# WRITTEN COMMENTS TO SCOPING MEETING FOR WEST PARCEL SOLAR PROJECT, JUNE 7, 2017

## UNITED WALNUT TAXPAYERS PRELIMINARY REVIEW OF NEGATIVE GEOTECHNICAL AND GEOLOGICAL ASPECTS OF CONSTRUCTING EARTHFILL PAD FOR A SOLAR FARM ON THE WEST PARCEL - DRAFT

Attachment Google Earth Image of Existing Landslide at West Parcel Site

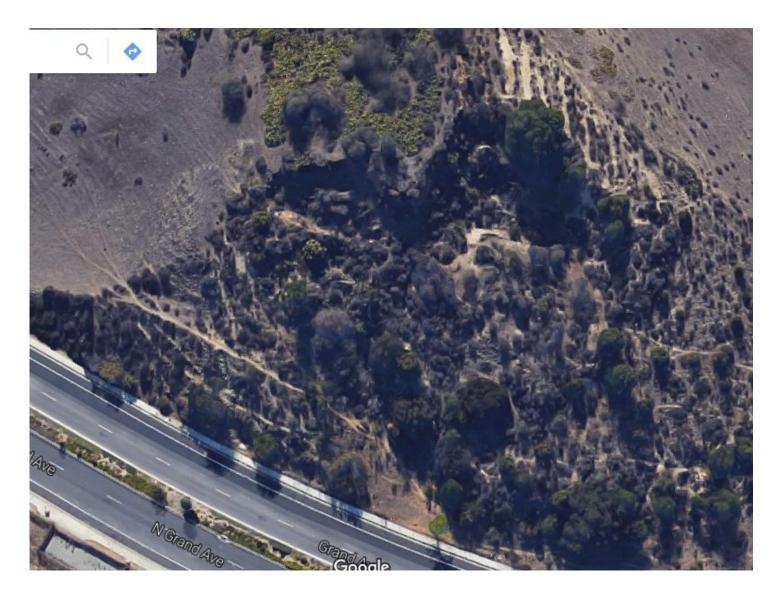
vii. The Converse report did not recognize a significant landslide in the central hill of the project site present for more than thirty years (see Google Earth attachment), which is vulnerable to further sliding.

iv. Aerial imagery from Google Earth clearly indicates landslide(s) exists on the eastern side of the central knob descending down to Grand Avenue (see attachment). The landslide area on the central hill is present in aerial imagery dating from after 1980 until the present.

i. The landslide at the central hill along Grand Avenue likely took place along easterly out of slope bedding orientations.

i. The landslide at Grand Avenue occurred about 1980 shortly after Grand Avenue was widened to four lanes in the late 1970's, likely from the undercutting of the central hill near the roadway.
